***JAPAN's Comments on
Head Restraint Height
Proposal from
the Netherlands***

GRSP INFORMAL WORKING GROUP ON HEAD RESTRAINTS

June '05

JAPAN MLIT

2. Study of Possible Effects on Mini Cars

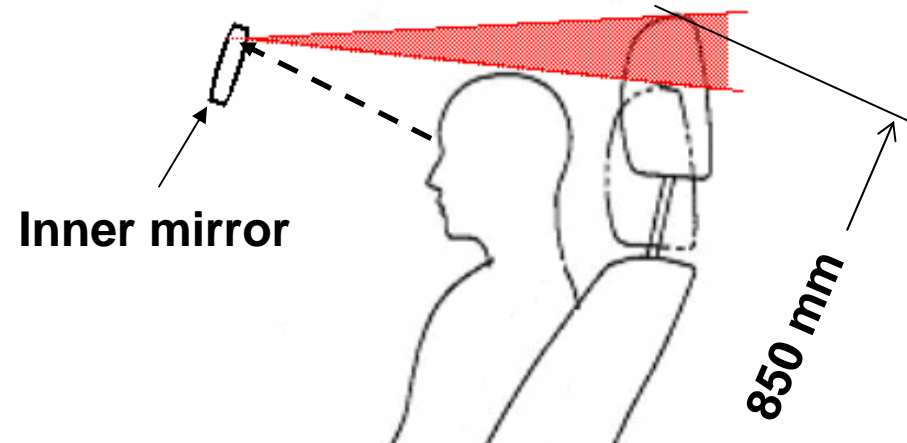
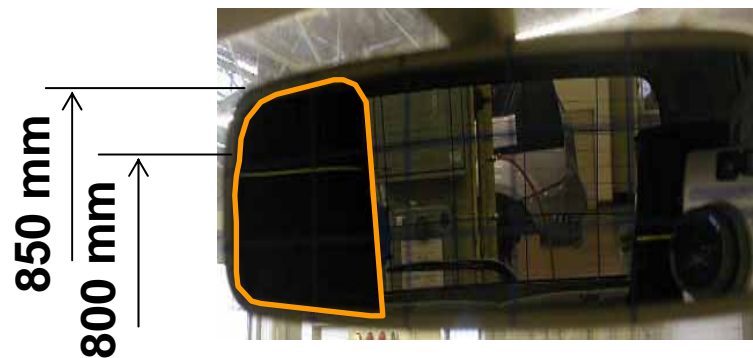
(1) On direct rearward and rearward oblique visibility

Affected by the head restraint width, but hardly affected by its increased height.

(2) On indirect rearward visibility

At the maximum head restraint height, visibility through the inner mirror greatly affected due to a limited vehicle width.

- Height-adjustable head restraints are likely to be required.

(2) On head restraining capability

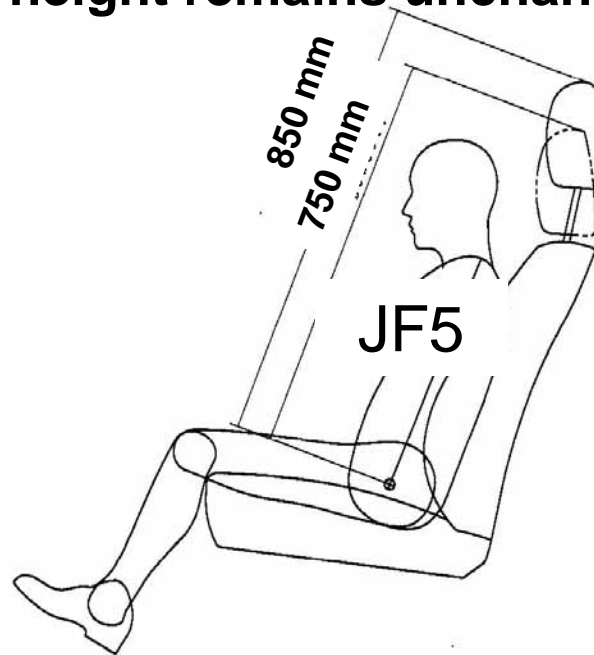
Not affected by the increased height of head restraints, provided the minimum height remains unchanged.
